**Overview:** The initial production release of the FTI-TLK1 harness has an issue where in some vehicles the secondary power input to the CN1 connector will overload the associated vehicle circuit, causing a fuse to blow. This issue affects the initial release of harnesses and is already being addressed in production. A field correction procedure is detailed below in Figure 1.

# FTI-TLK1 Type 1B - Vehicle Coverage & Preparation Notes

# FTI-TLK1 Type 1B - Installation Notes & Wiring Diagram

**Figure 1: Step by step adapter correction**

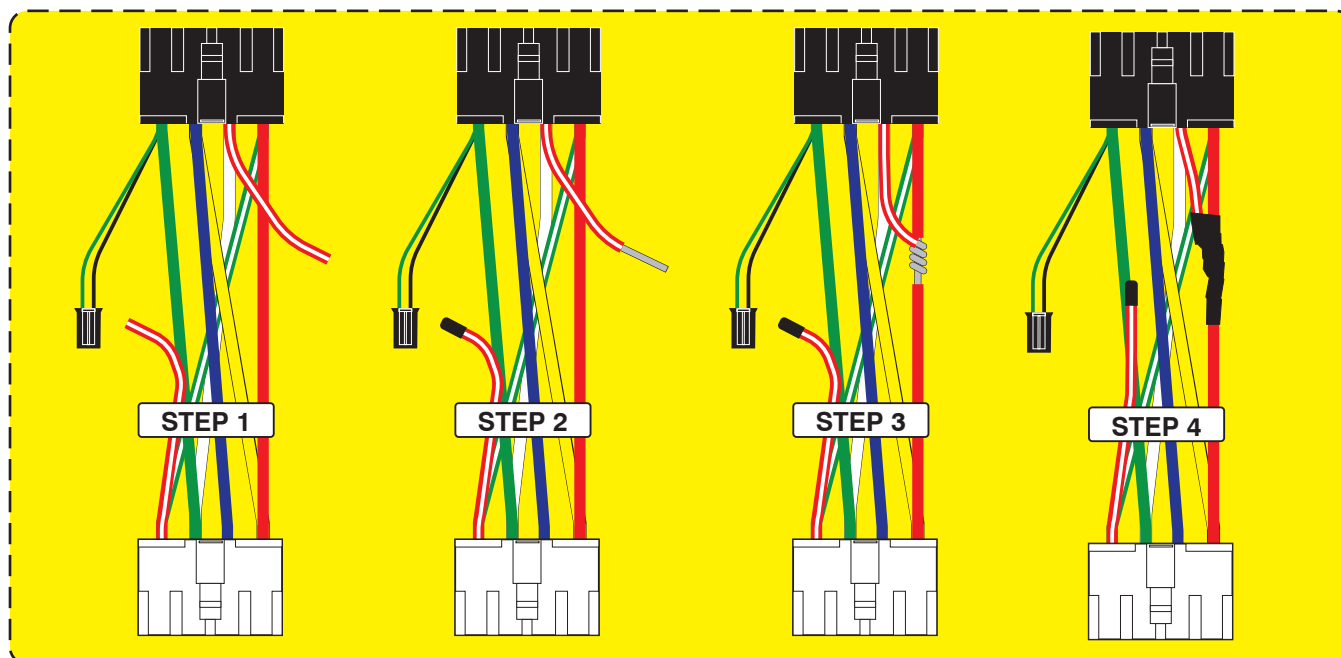
**Issue:** The secondary power circuit can overload some vehicle ignition switch circuits, causing a blown 5A/7.5A AM1 fuse, potentially disabling the vehicle and leaving the consumer stranded. Affected adapters are illustrated below in figure 2.

- 1.) Select the applicable CN1 adapter, isolate the RED/WHITE power wire, cut wire approximately 4" from the BLACK plug
- 2.) Insulate the wire still connected to the WHITE plug using heat shrink tubing, and strip the insulation on the other wire end
- 3.) Strip a portion of the insulation from the RED wire, attach the stripped RED/WHITE to the exposed RED wire, solder together
- 4.) Apply insulating tape to the soldered connection and secure the cut ends back to the bundle of wires created by the adapter
- 5.) Correction complete, you may safely proceed to finish your installation

**Figure 2: Supplied CN1 Harness Adapters**

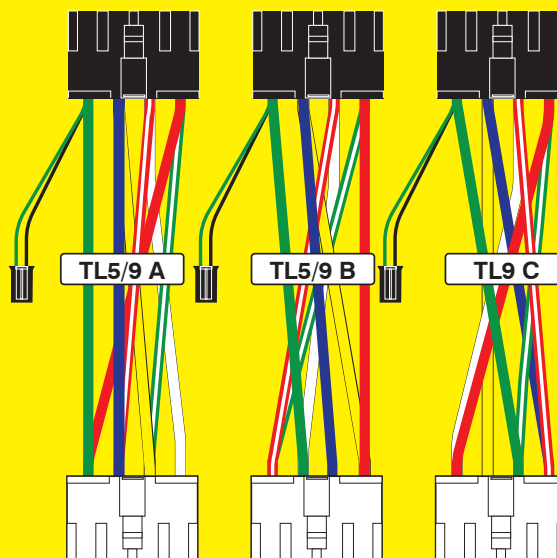
Incorrect power provisions with the potential to overload vehicle ignition supply circuit, resulting in blown AM1 fuse.
